Bulletin 4

FM1200 control board Type 4, sub-version 3513 0 1673

Figure 1

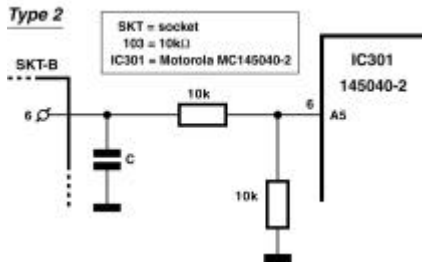
As shown in **Figure 1**, on Type 2 boards the output voltage of the internal SWR meter is applied to input A5 of the ADC, via pin 6 of socket SKT-B.

Figure 2

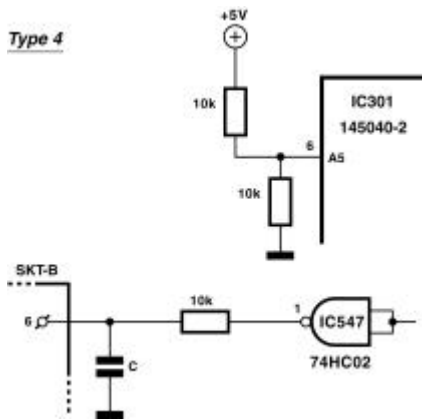
By contrast, on Type 4 boards pin 6 of SKT-B is used to get a POCSAG digital signal across to the analogue board, while the A5 input of the ADC is held at a fixed level of approx. 2.5V by means of a voltage divider; see **Figure 2**. Consequently the new control software will invariably read a bad SWR condition via the ADC. The problem is simple to resolve by hardware-modifying the Type 4 board in such a way that it gets the same functionality as a Type 2 board. POCSAG not being too much of an issue to radio amateurs it needs to be sacrificed.

Figure 3

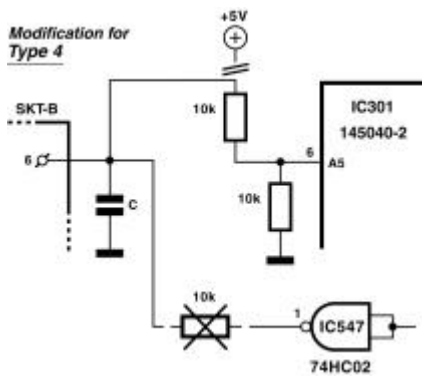
The circuit diagram of the modification for Type 4 control boards is given in **Figure 3**.

Figure 4

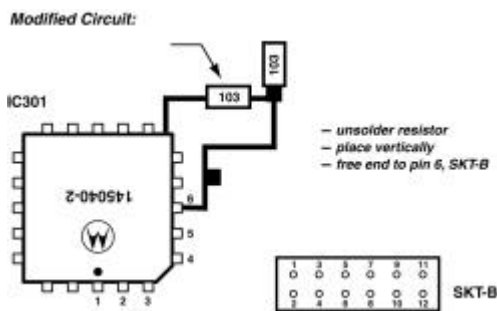
1. Remove the 10k SMD resistor (print: 103) found in the right-hand upper corner of the board, near the yellow '4'.
2. Carefully remove the 10k resistor indicated by the arrow in Figure 4. Re-mount this resistor, this time vertically, with the lower end soldered to the nearby 10k resistor.
3. connect a wire between the upper terminal of the vertically fitted resistor and pin 6 of SKT-B.

If the 10k SMD resistor is damaged or lost, solder a regular-size 10k resistor between the square solder pad on the track to pin 6 of the MC145040 ADC (IC301) and pin 6 of SKT-B.
